Docket Number:	21-AFC-02
Project Title:	Willow Rock Energy Storage Center
TN #:	259736
Document Title:	Willow Rock Data Request Set 4 Response
Description:	N/A
Filer:	Kathryn Stevens
Organization:	WSP USA Inc.
Submitter Role:	Applicant Consultant
Submission Date:	10/28/2024 4:49:53 PM
Docketed Date:	10/28/2024

Willow Rock Energy Storage Center (21-AFC-02)
Data Request Response Set 4

October 2024

TITLE
CAVERN TOP HEADING VIBRATIONS OUT TO 0.5 MILES

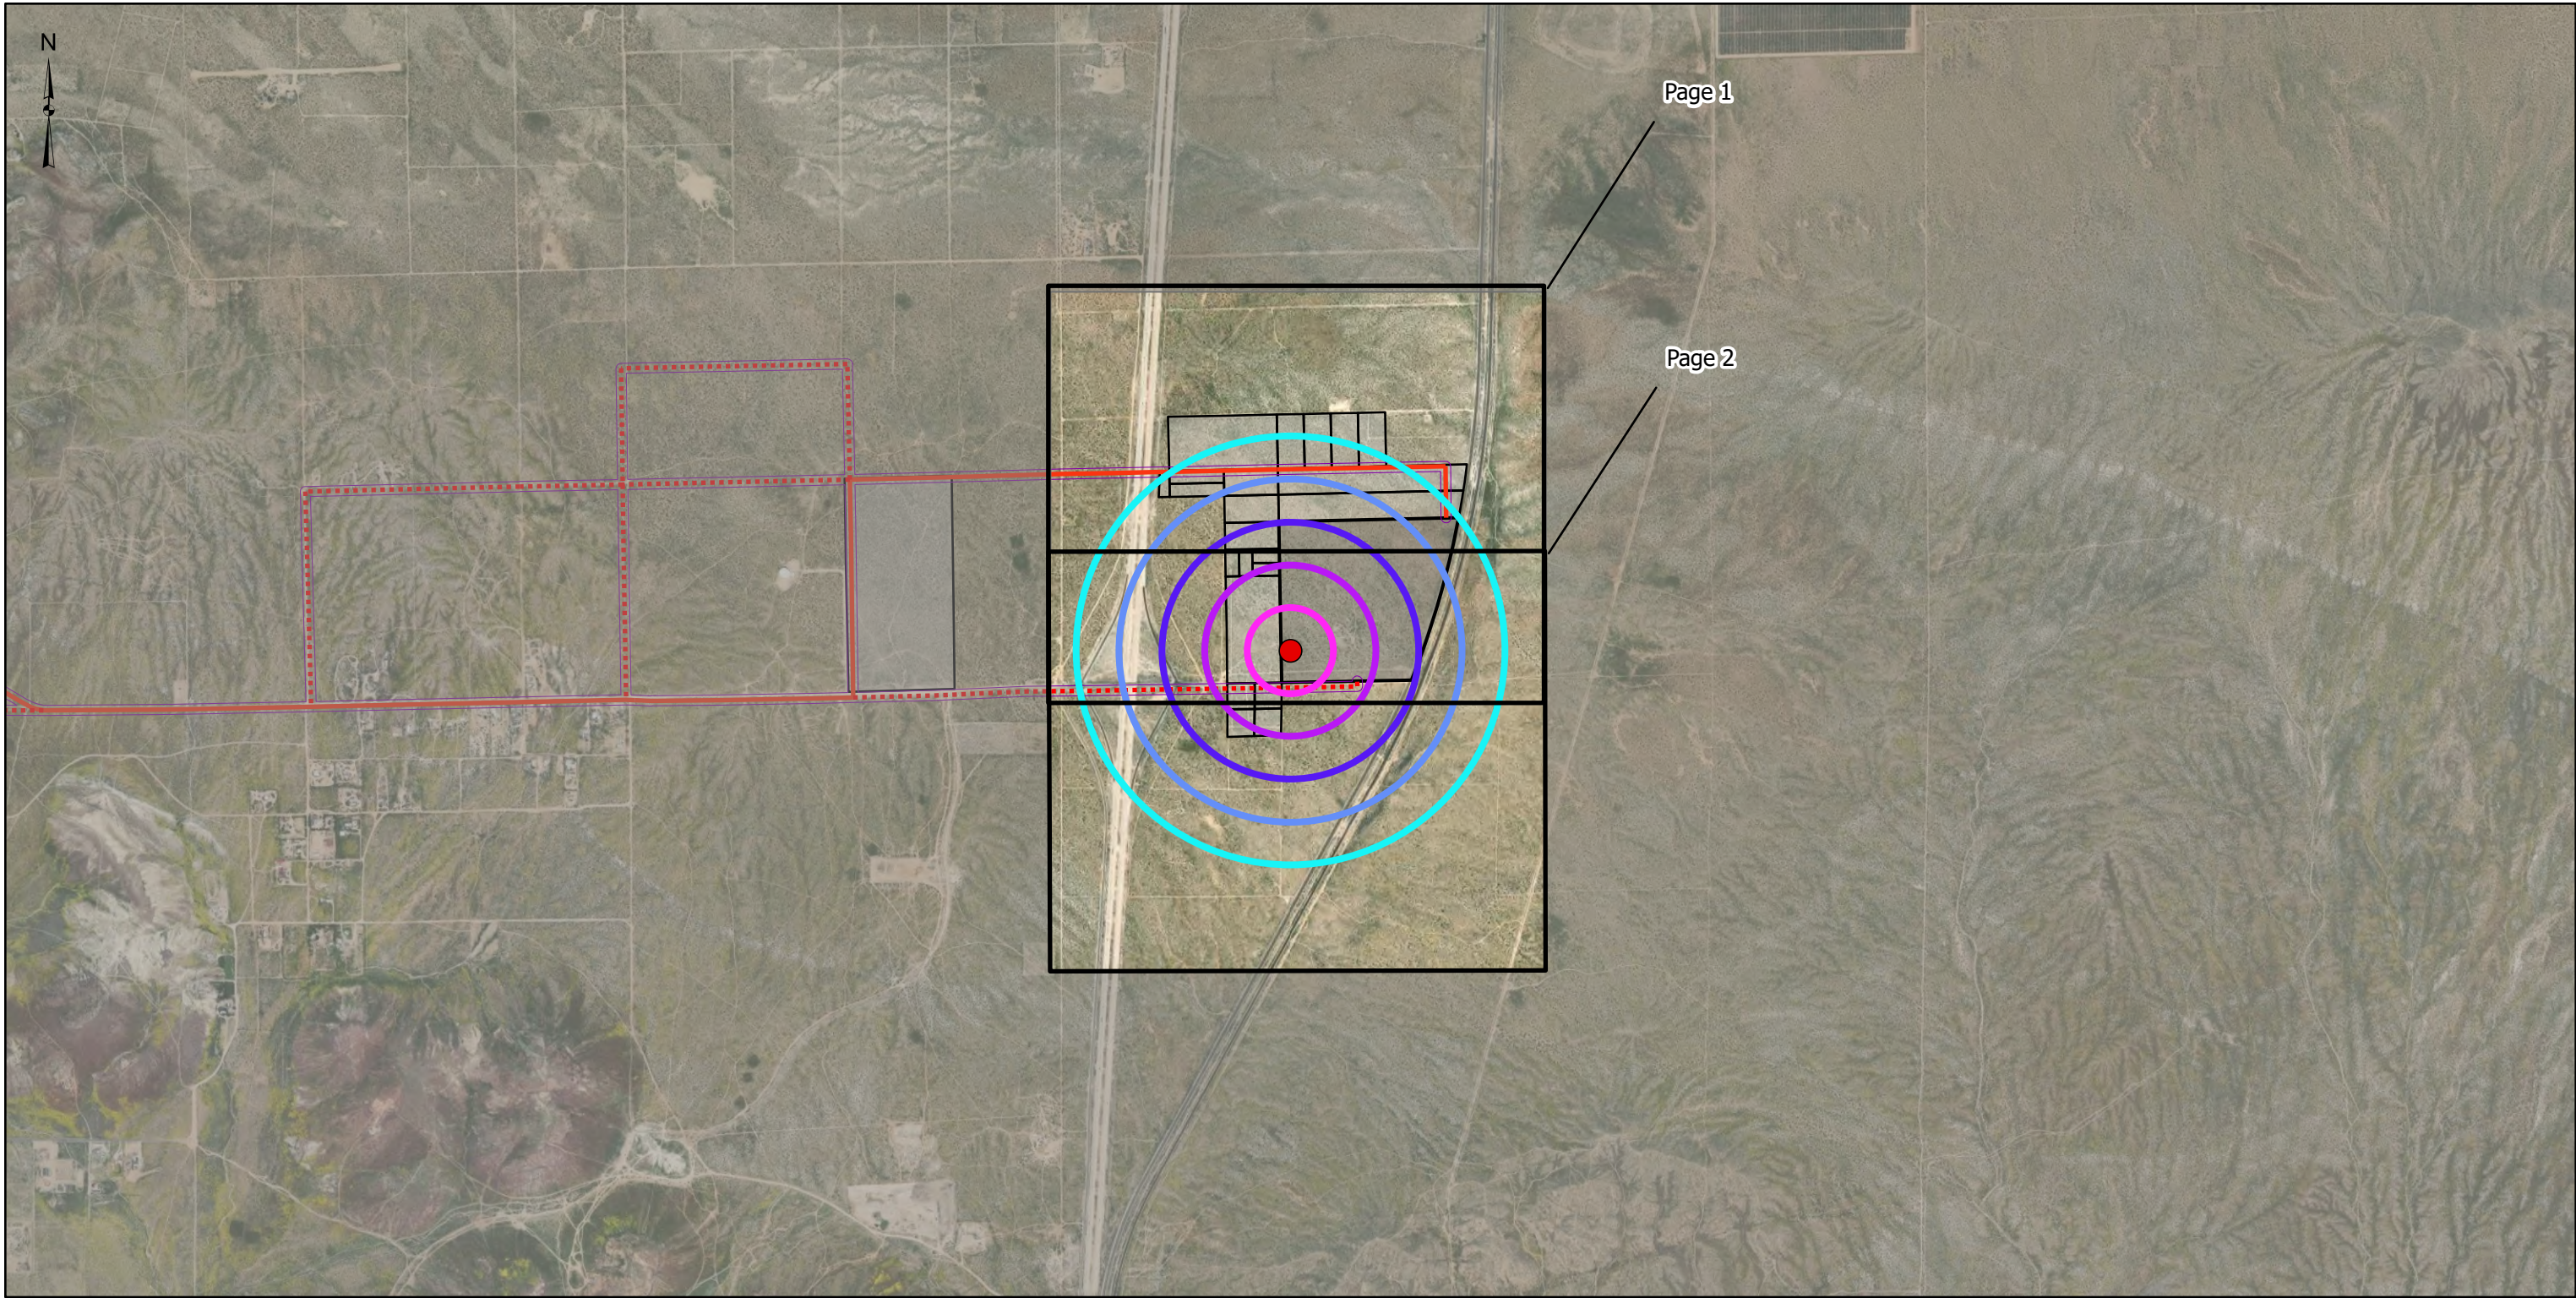
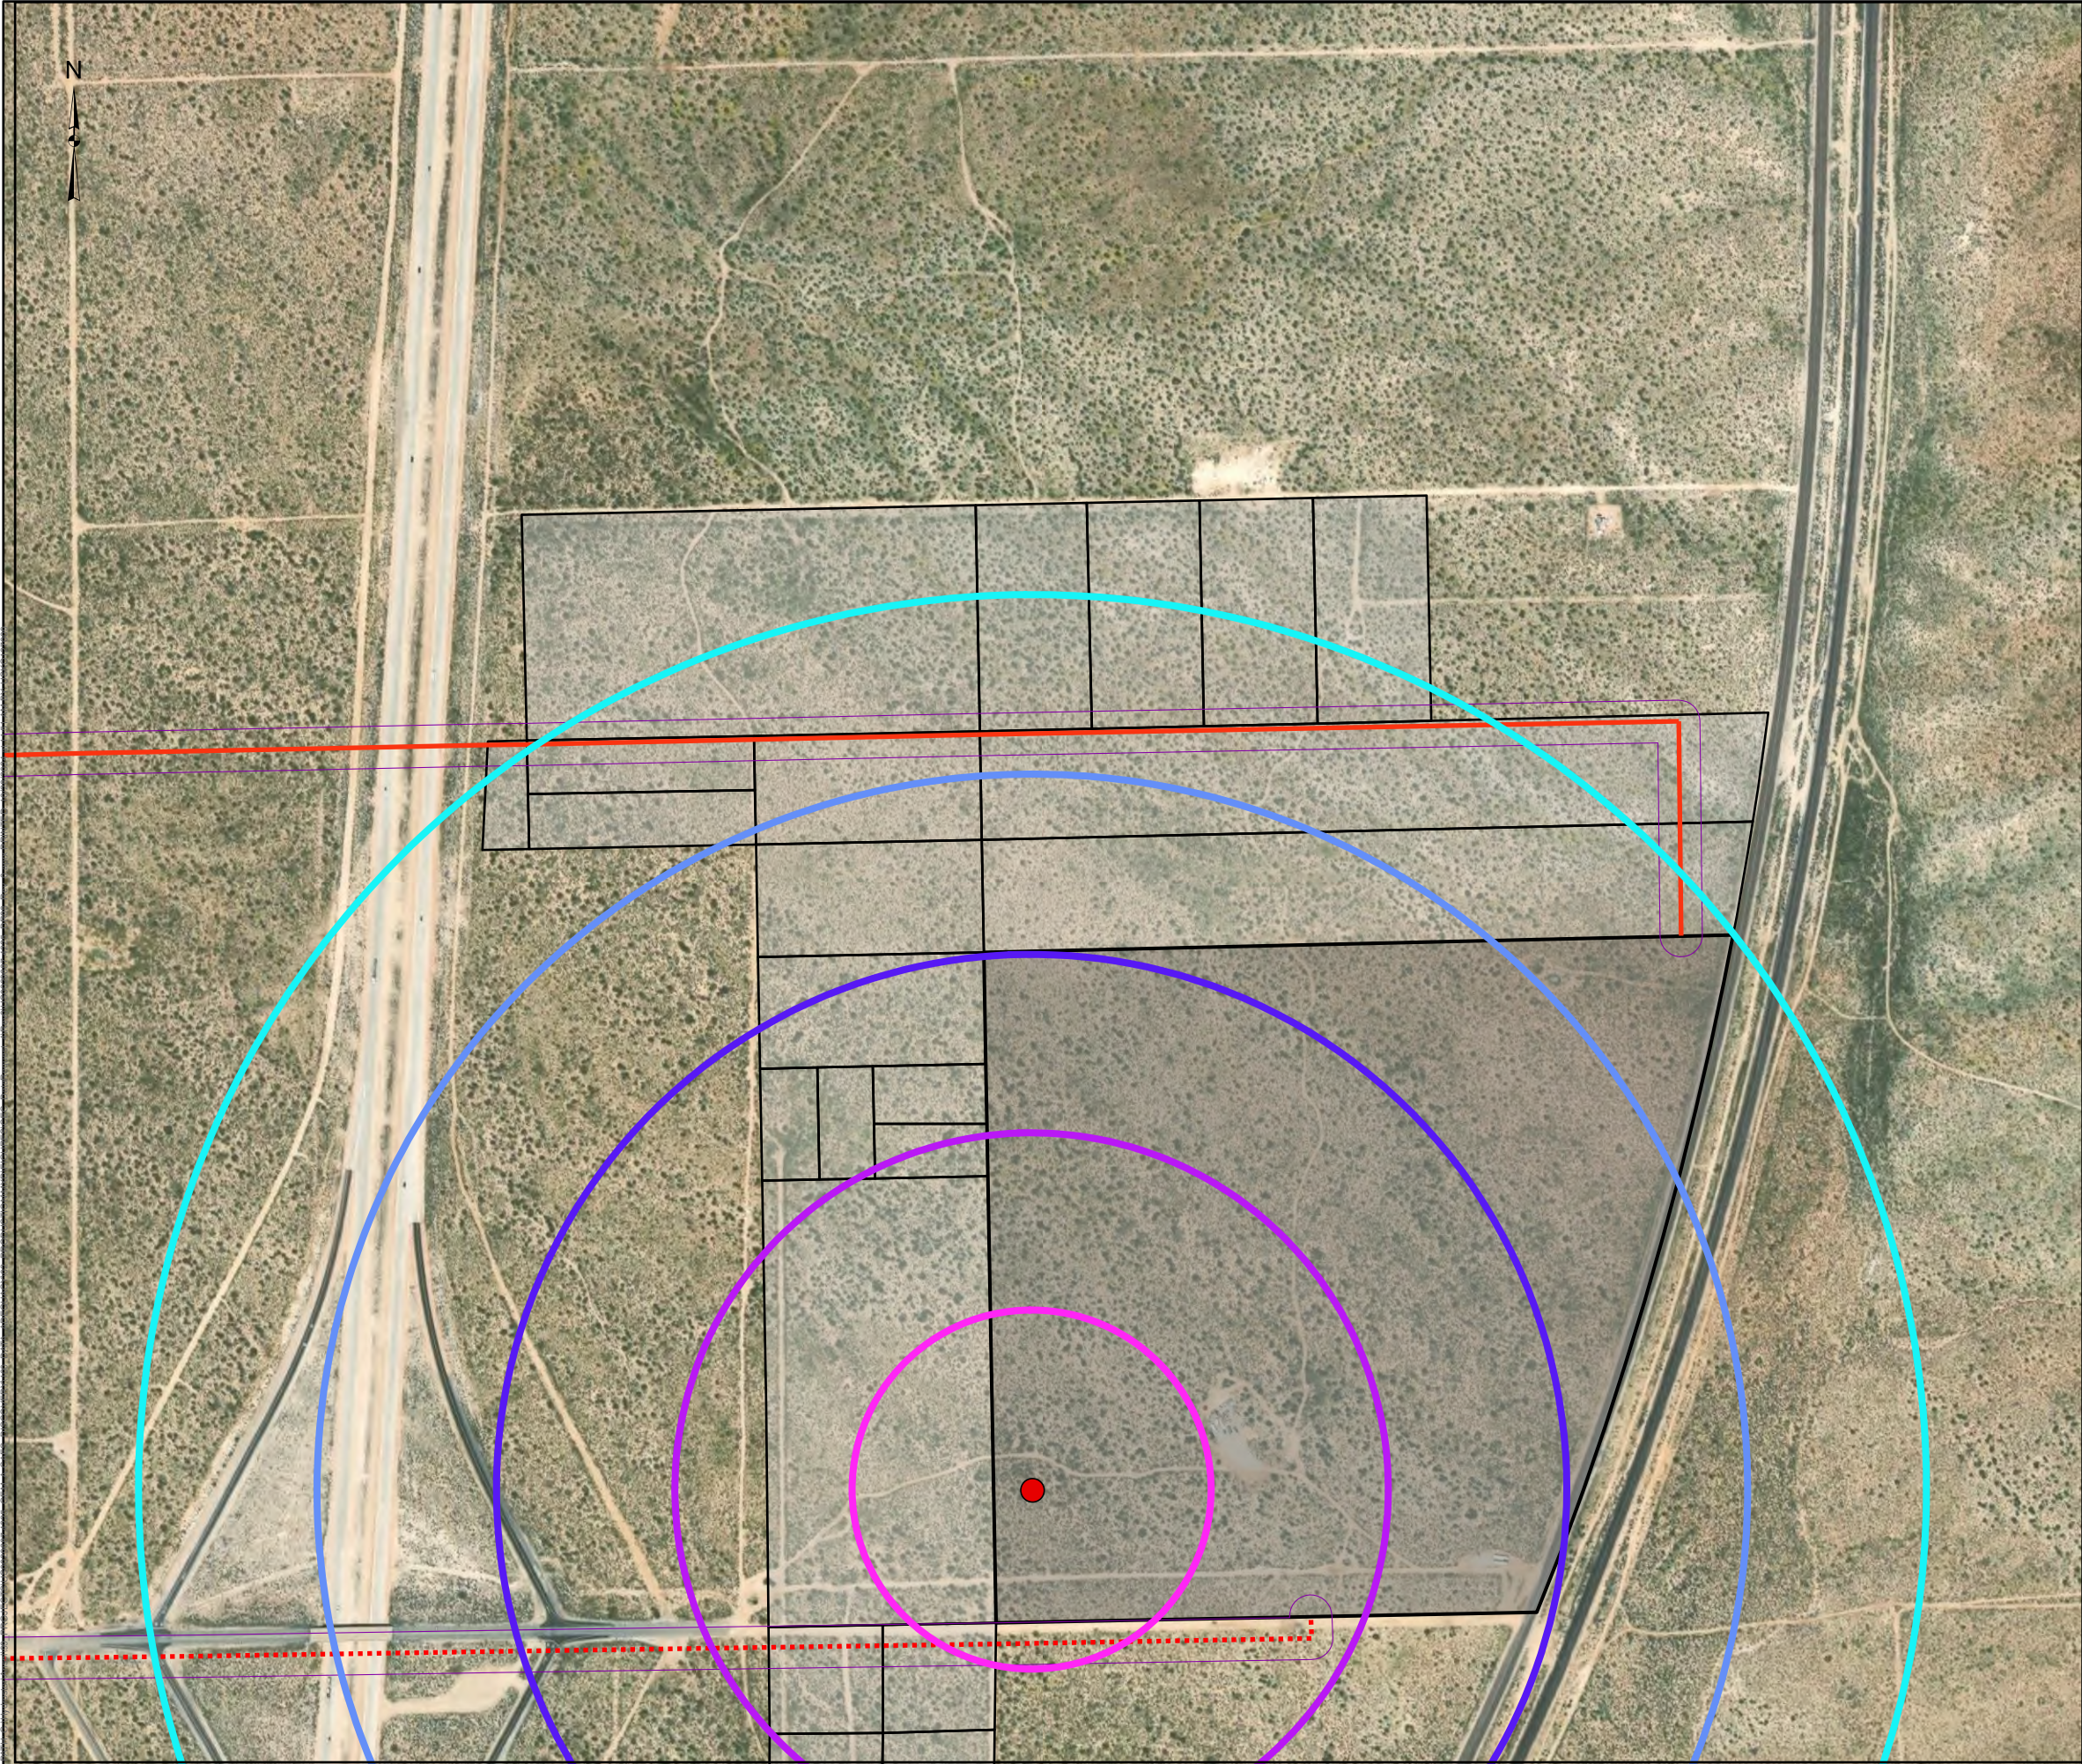
DR98: *Please provide an aerial imagery map (at a scale of 1:6000) showing the attenuation of sound and vibration out to 0.5-mile.*

Response: Figures depicting the attenuation of sound and vibration are provided in **Attachments DR98-1, Figures DR98A; Attachment DR98-2, Figures DR98B; Attachment DR98-3, Figures DR98C; and Attachment DR98-4, Figures DR98D.** Please note that these are extremely short events that last in most instances for less than a few seconds, with the longest duration in the 6-8 second range.
